PRATT & WHITNEY CANADA
SERVICE BULLETIN

TURBOSHAFT ENGINE
SEAL, STARTER GENERATOR PAD/FCU PAD/ACCESSORY PAD - REPLACEMENT OF
MODEL APPLICATION

PW200-72-28197
Cover Sheet

SUBJECT: Pratt & Whitney Canada Service Bulletin No. PW200-72-28197, Rev. No. 8, dated Jun 02/2022 (P&WC S.B. No. 28197R8) SEAL, STARTER GENERATOR PAD/FCU PAD/ACCESSORY PAD - REPLACEMENT OF

Tool PWC64886 - Installation of
Figure 1

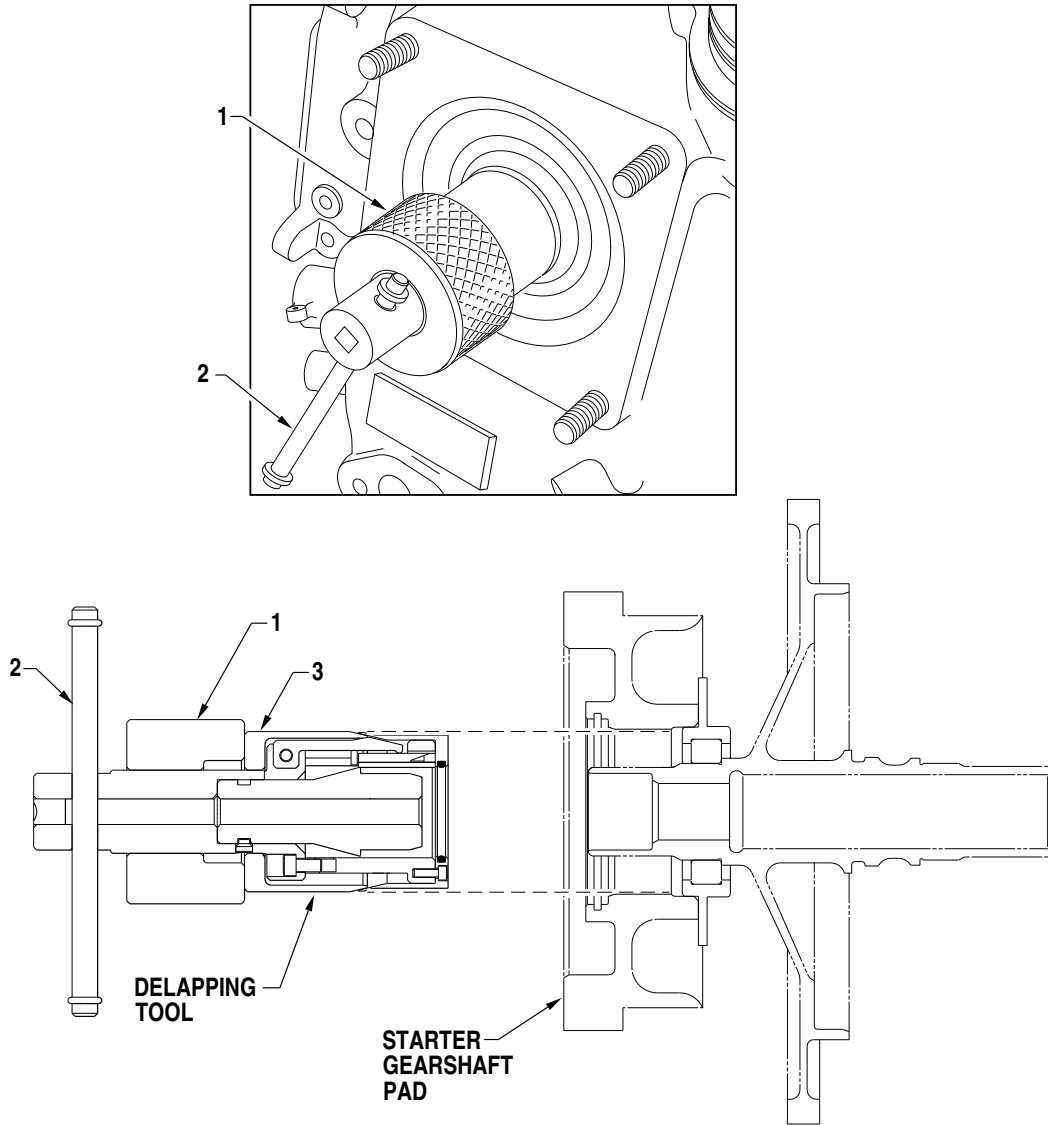
(3) Rework the surface-finish of the gearshaft as follows (Ref. Fig. 1):

(a) Install the tool (PWC64886) on the gearshaft seal journal.

(b) Push the tool on the gearshaft, turn and push collar (Item 3) to ensure it is engaged, and screw the nut (item 1) until the tool starts turning.

(c) Turn the handle (Item 2) six revolutions.

Magnetic Seal - Installation of
Figure 2

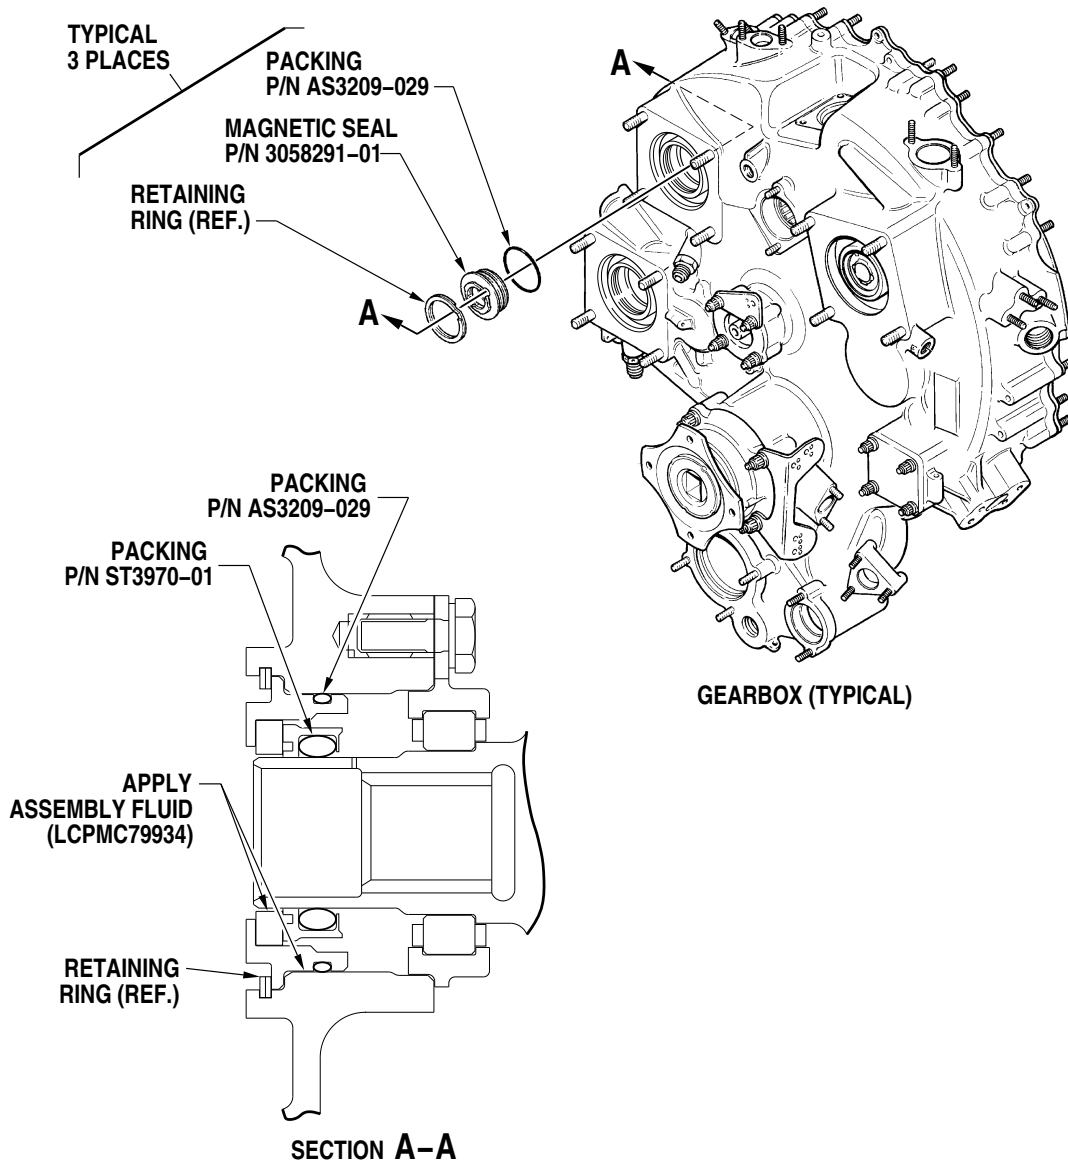
(4) Install the parts listed under New P/N in Para. 2.C., Material Information, in accordance with the maintenance or overhaul manual instructions as follows(Ref. Fig. 2):

(a) Apply a small amount of assembly fluid on shaft outside diameter and on AGB Housing bore where shown (Ref. Fig. 2).

(b) Install the magnetic seal on gearshaft and ensure part is seated by hand.

Starter Generator Drive Gearshaft - Rework of
Figure 3

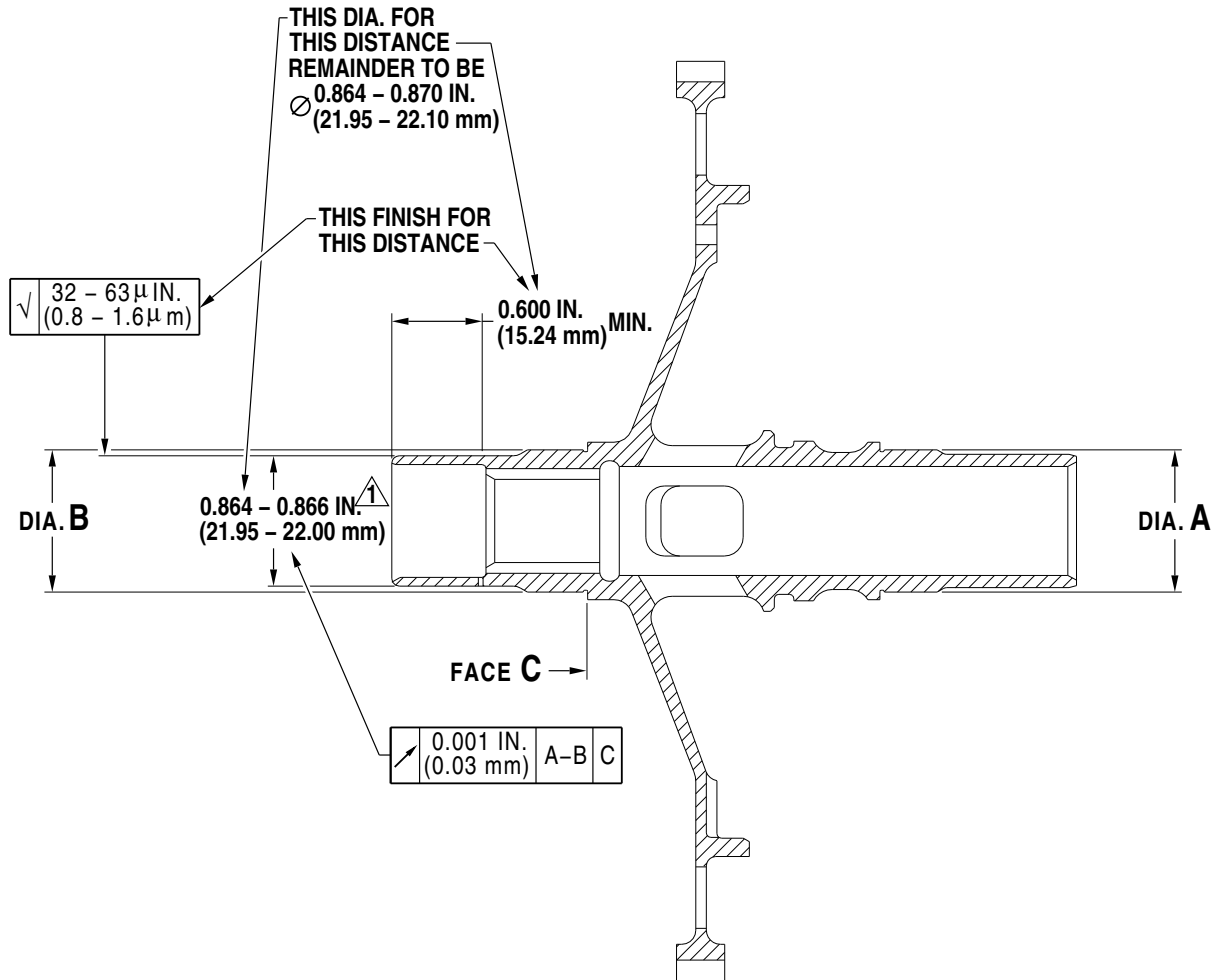
- (2) Retain the retaining-ring for installation of seal.
- (3) Do an inspection of the gearshaft surface finish in area shown and make sure it is 32 μ in. (0.8 μ m) to 63 μ in. (1.6 μ m) (Ref. Fig. 3, 4, 5).
- (4) If the gearshaft surface finish is not within tolerance, rework the surface finish as follows (Ref. Fig. 1):

⚠ DIAMETER MAY BE 0.001 IN. (0.025mm) UNDER MINIMUM AFTER REWORK.

Fuel Control Drive Gearshaft - Rework of
Figure 4

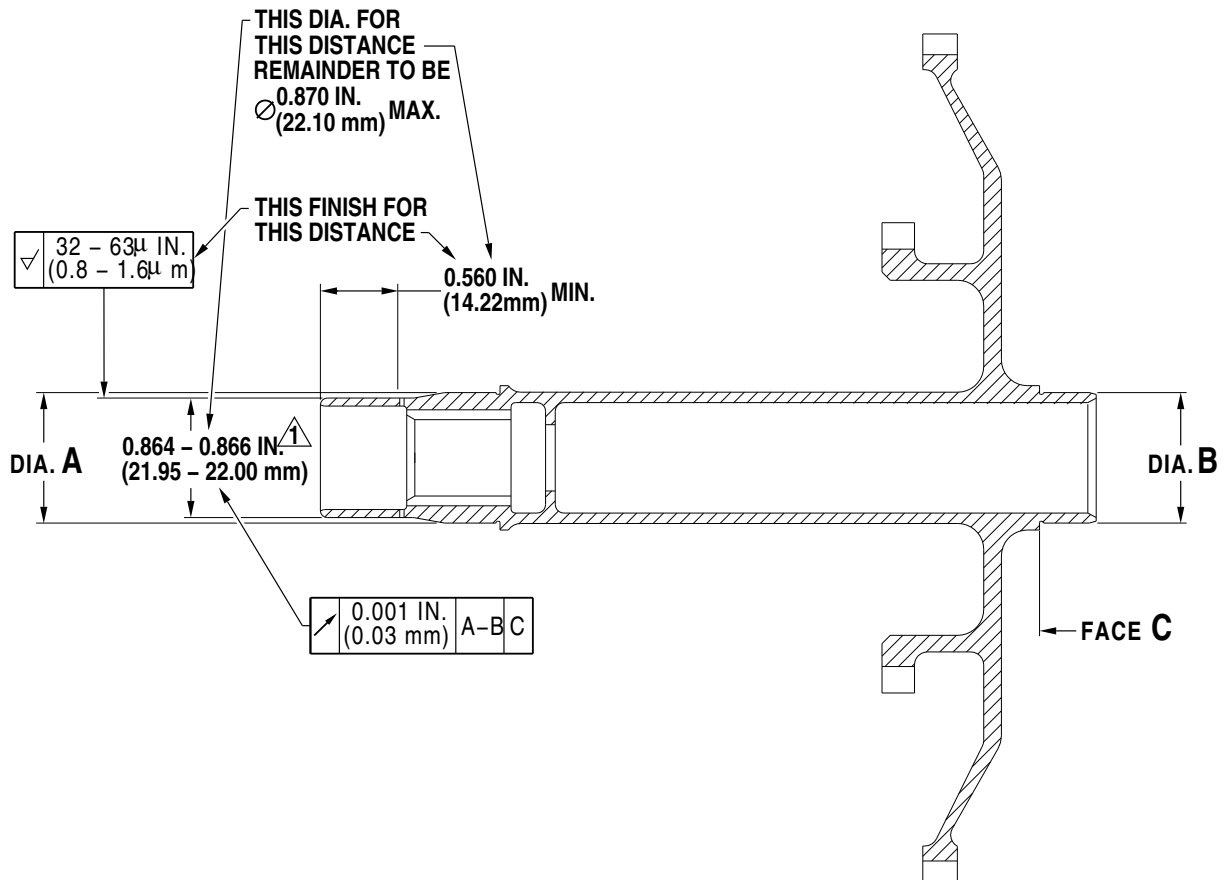
DIAMETER MAY BE 0.001 IN. (0.025mm) UNDER MINIMUM AFTER REWORK.

Alternator Drive Gearshaft - Rework of
Figure 5

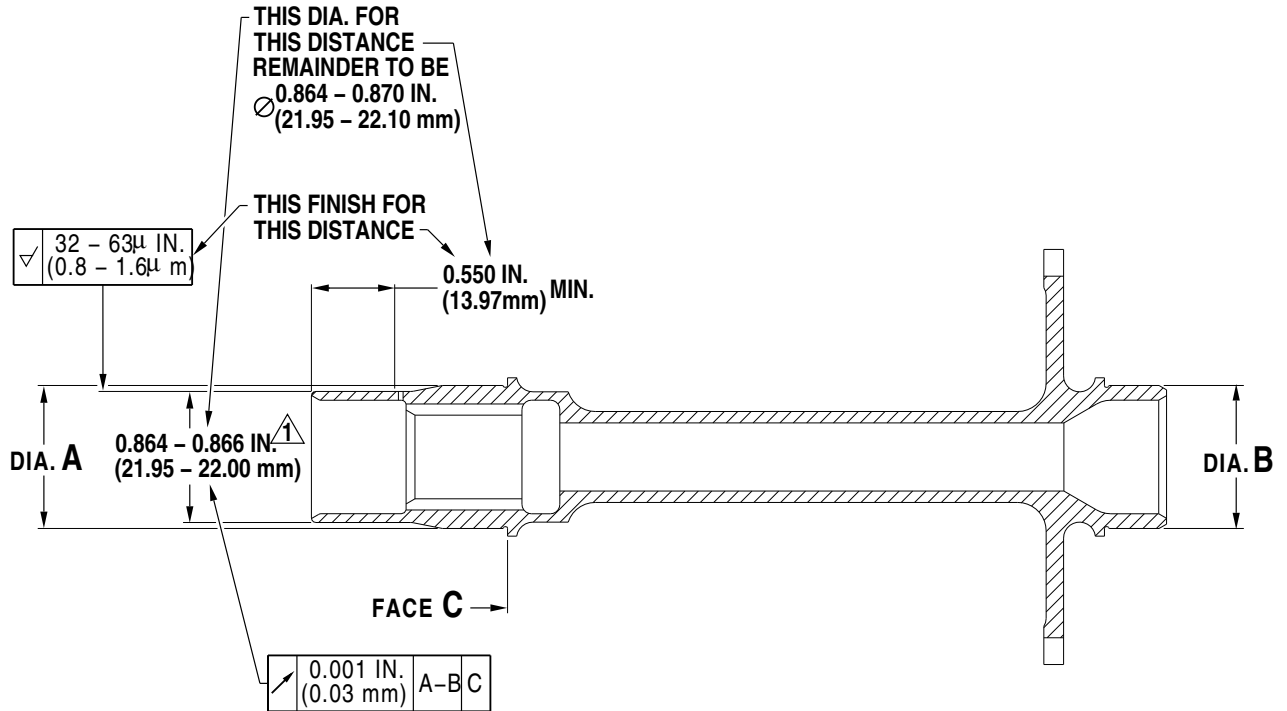
¹ DIAMETER MAY BE 0.001 IN. (0.025mm) UNDER MINIMUM AFTER REWORK.

Seal - Part Progression
Figure 6

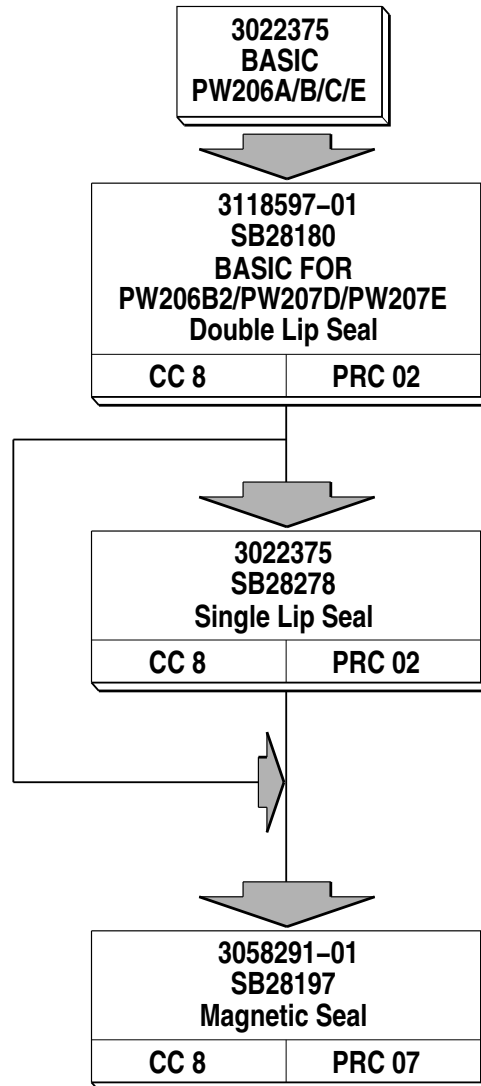
A. Refer to Figure 6 for part progression.
